**CTC Meeting #26  
April 8 - 9, 2013  
Unenclosed Exits**

**F137 – 13**

**202, 903.3.1.2.2 (New) [IBC [F] 903.3.1.2.2 (New)], 1104.21**

**Proponent:** Al Godwin, CBO, CPM, Aon Fire Protection Engineering, representing Aon Fire Protection Engineering Corporation (al.godwin@aon.com)

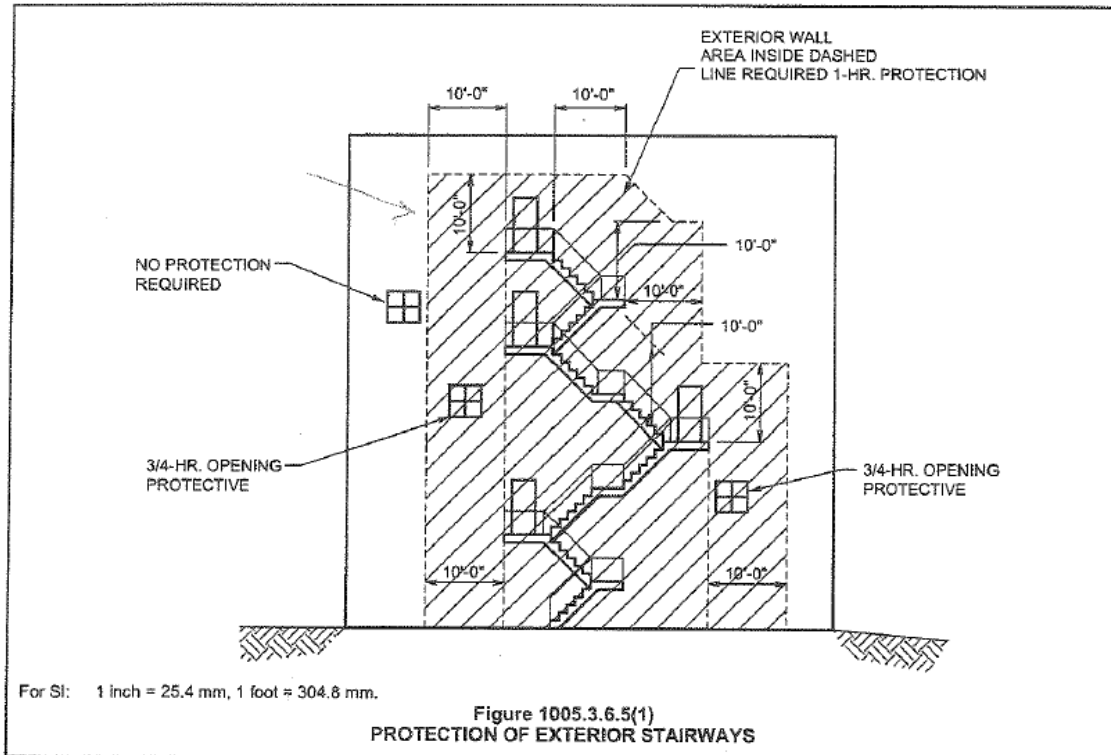
Many designers and jurisdictions assume that breezeway stairs are allowed by right. However, in order to not have to build the wall and fire door separating the exterior stair from the interior corridor, exception 4 must be complied with, which includes sprinklers in this breezeway.

The following is a representation of the intent of Exception 4, allowing the removal of the separation wall and door:

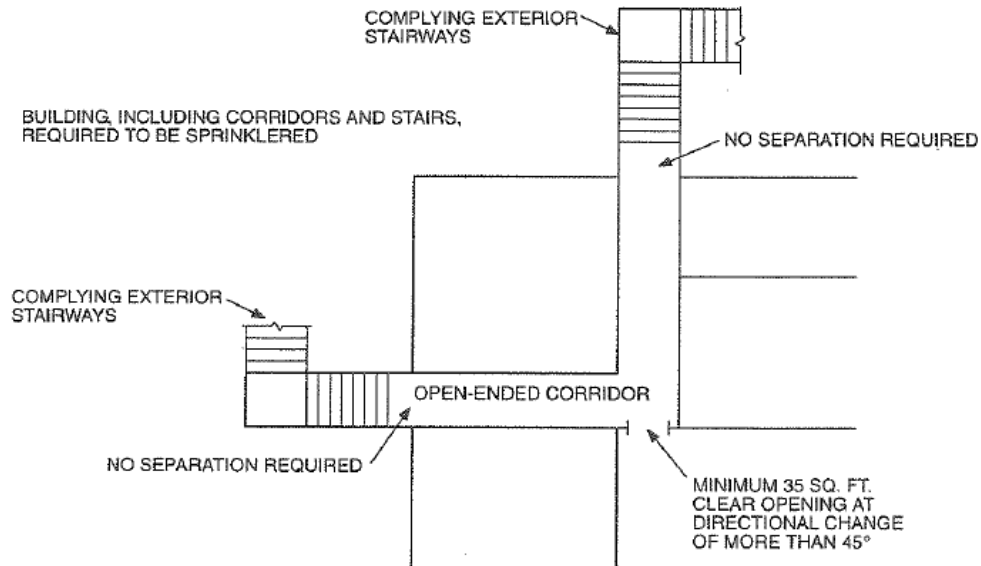
We are all familiar with the required protection on each side of the exterior stair as represented in this clip from the 2000 International Building Code Commentary.

So, if the walls on each side of the stair have to be protected, how can a large opening where the door occurs be removed and have an unprotected connection to the interior corridor.
